# Onsite Wastewater Treatment System Installation Permit

PERMIT DETAILS			
Permit No.: 136816	Record ID: ON0051294	Issued: May 23, 2022	Expires: May 23, 2023

## Conventional OWTS Application Review

Property Address: 6555 Cowboy Ranch Vw, Peyton, CO 80831 – 2nd SFR

# 6555 B Cowboy Ranch View

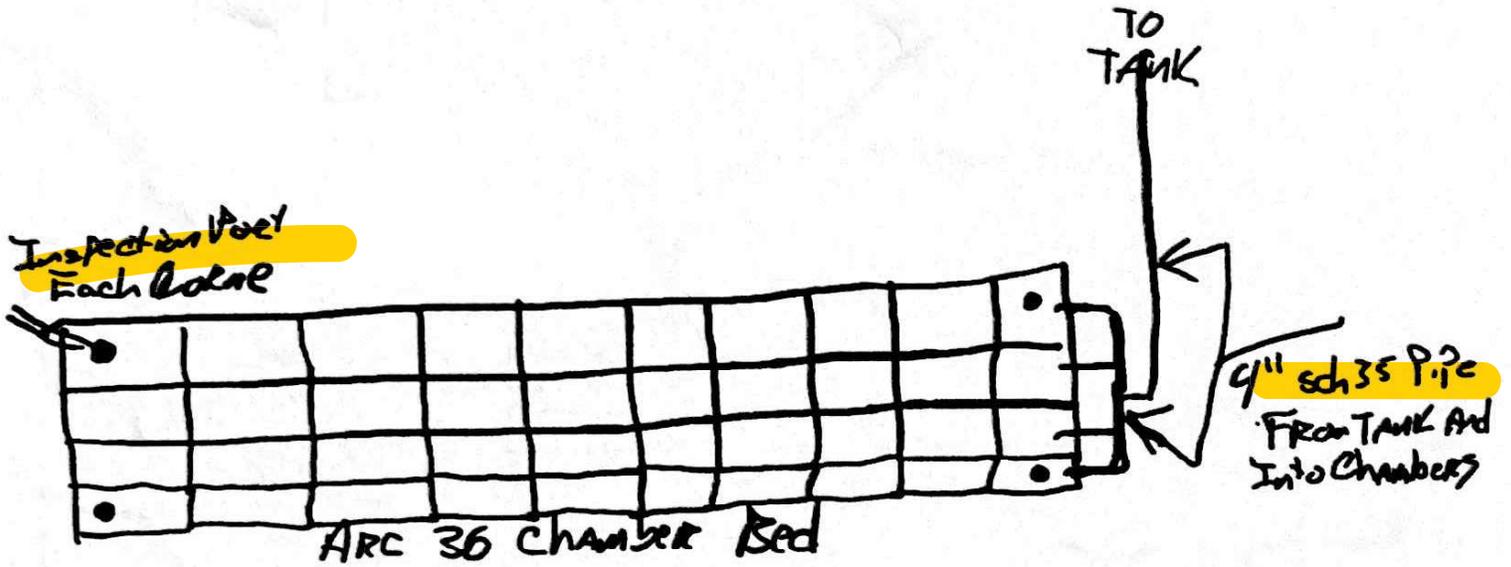
KH 04.27.2022

# 6555 Cowboy Ranch View Main House & Unit B Site Plan

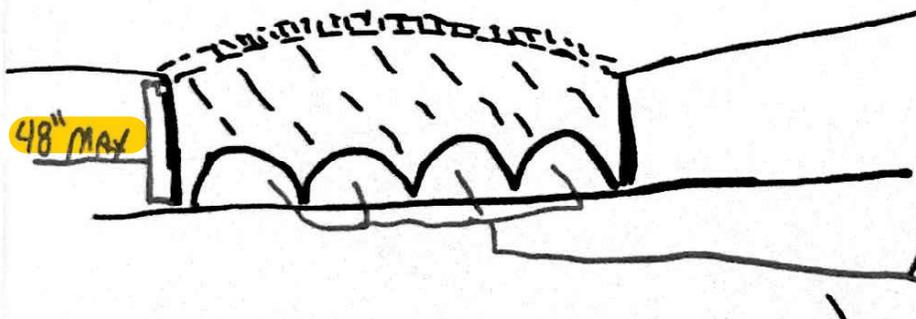
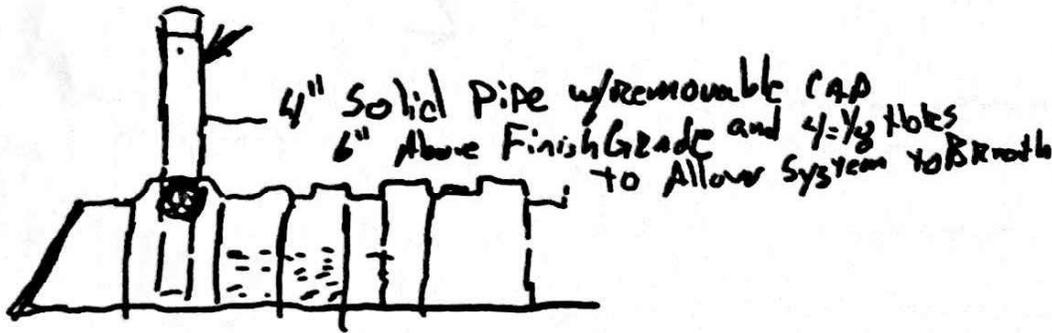
Installer has inaccurately labeled the profile pits in this site plan.  
Pit 3 in this diagram is Pit 2 (engineer report)  
Pit 4 in this diagram is Pit 1 (engineer report)  
Pit 2 in this diagram is Pit 4 (engineer report)  
Pit 1 in this diagram is Pit 3 (engineer report)
